Lot 54
Phase Dufferin
Model Criollo (42-12C) Elev B

Structurals

**FINAL STRUCTURAL REQUEST
ACKNOWLEDGMENT**

284
54
Elev. B

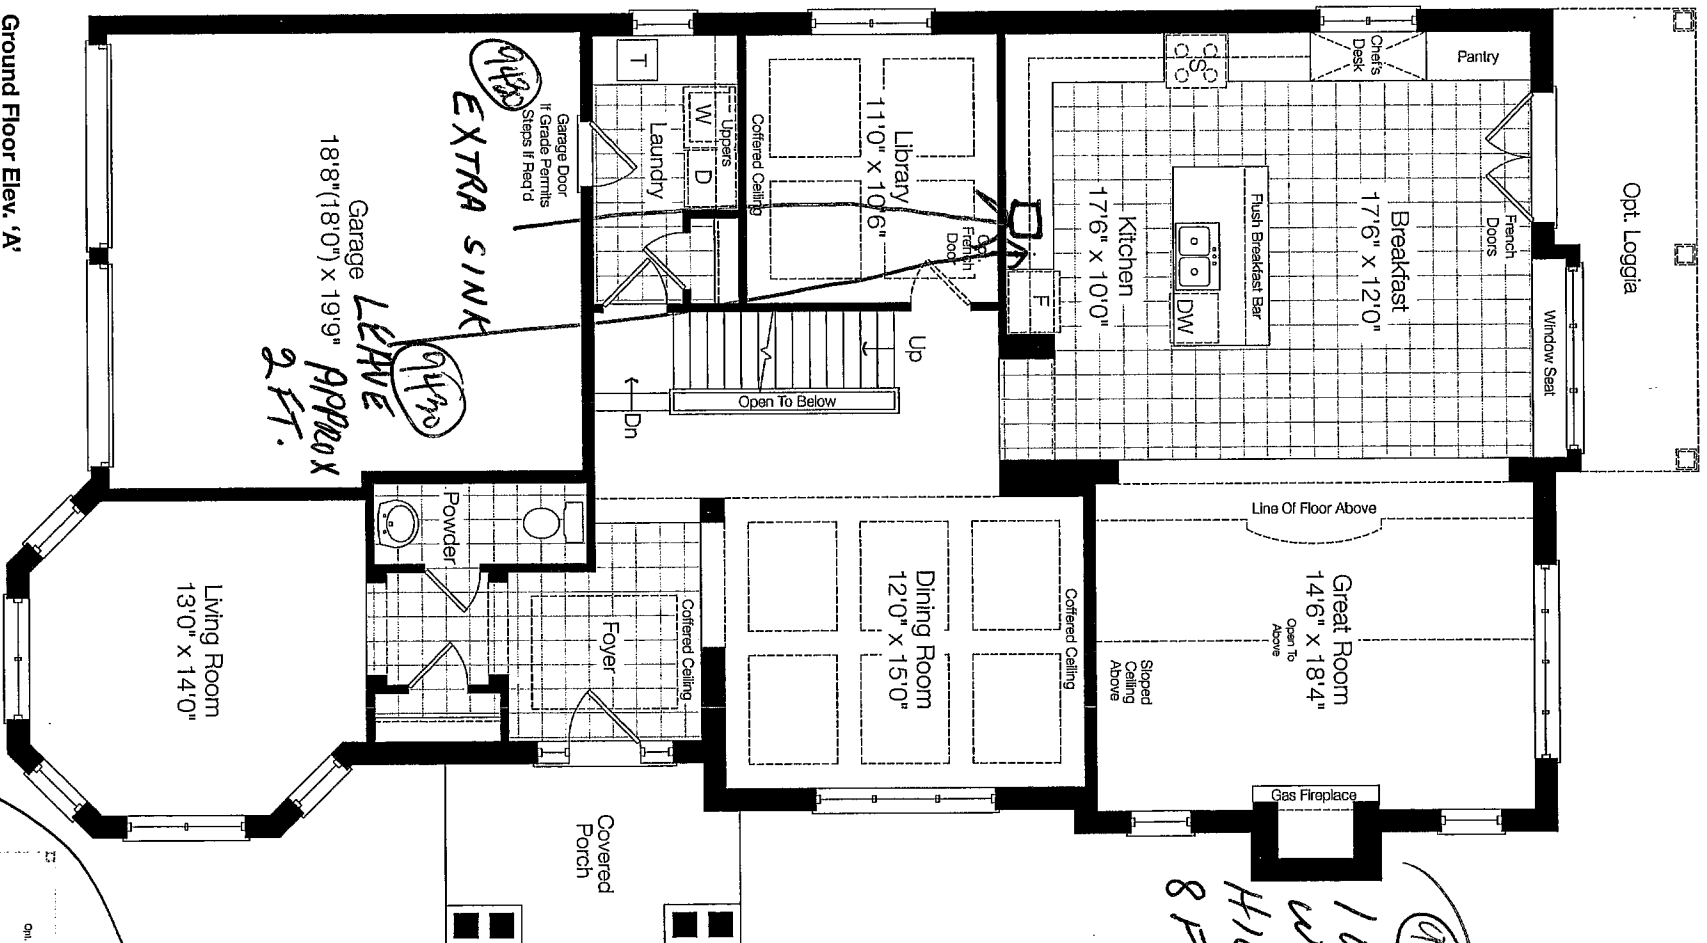
(9426)

10 FOOT MAIN FLOOR
WITH HIGHER ARCHES
HIGHER WINDOWS AND
8 FT. HOLLOW DOORS.

Second Floor Elev. 'B'

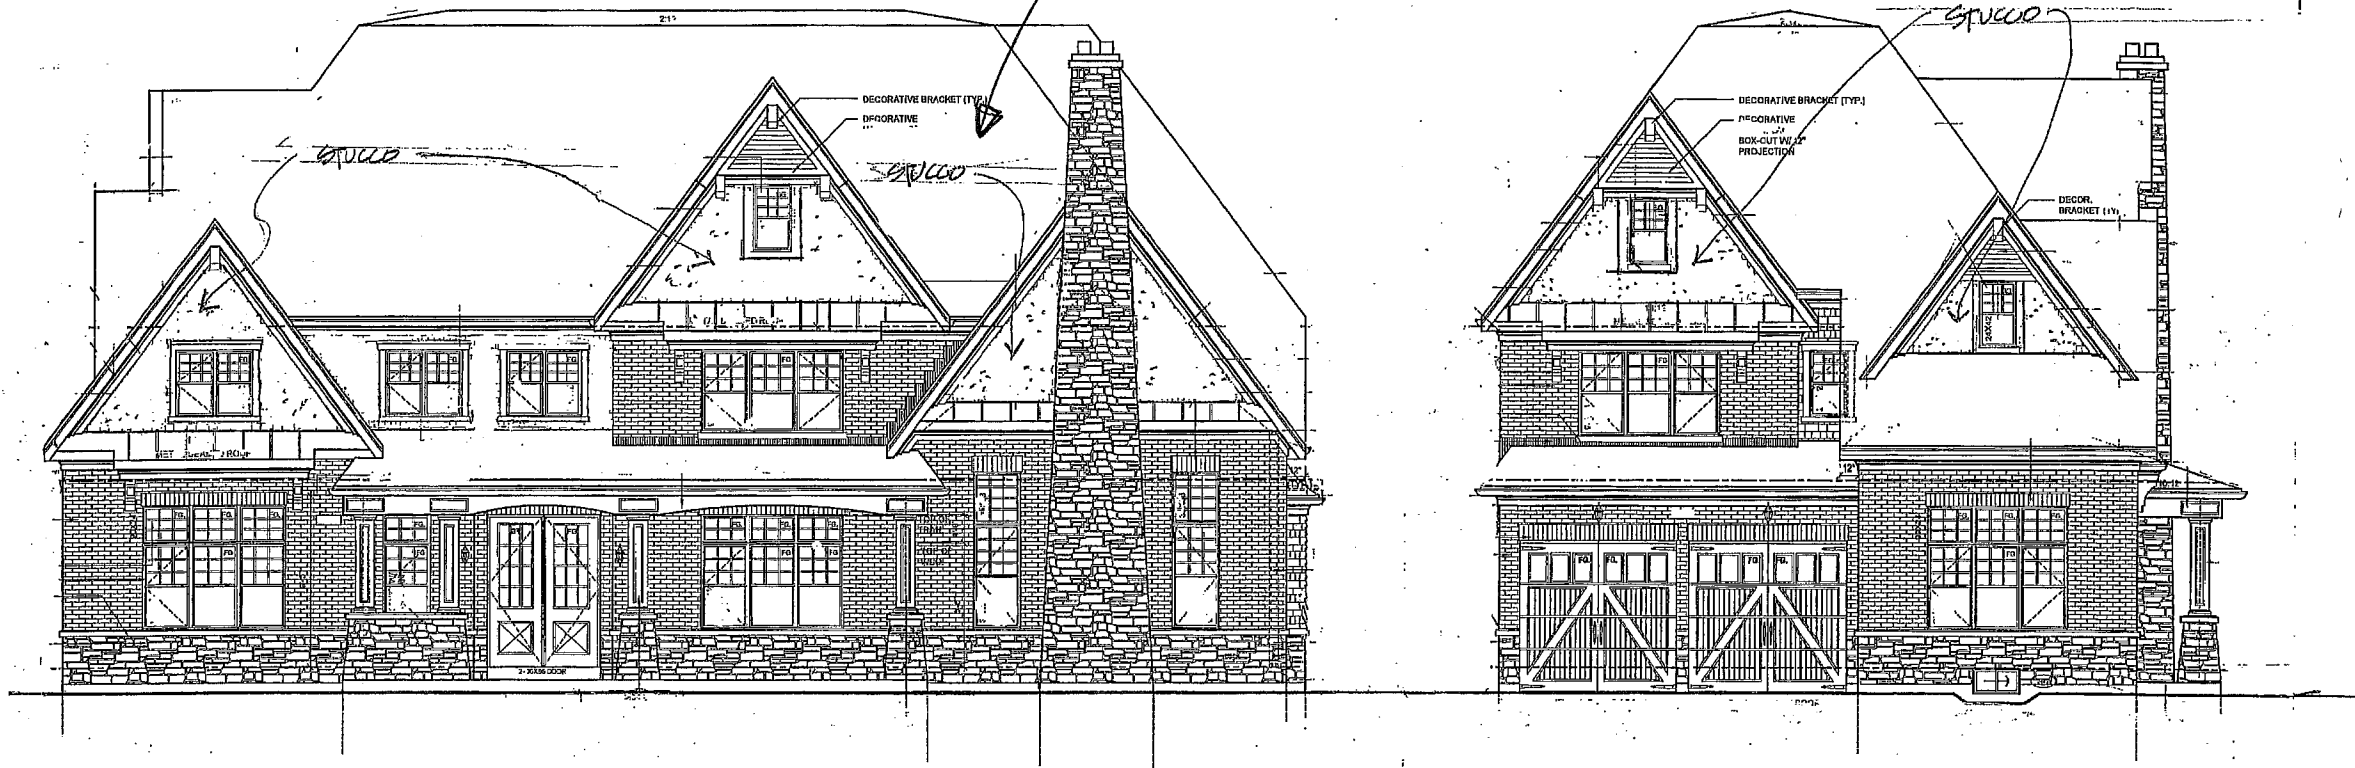
9487

9 FT. CEILING

TO 2ND

FLOOR

8546
Replace Hardie
shingles with stucco.

LOT 54 REPLACE HARDIE SHINGLES WITH STUCCO EXHIBIT B MODIFIED
PRELIMINARY SUBJECT TO FINAL ARCHITECTURAL APPROVALS.
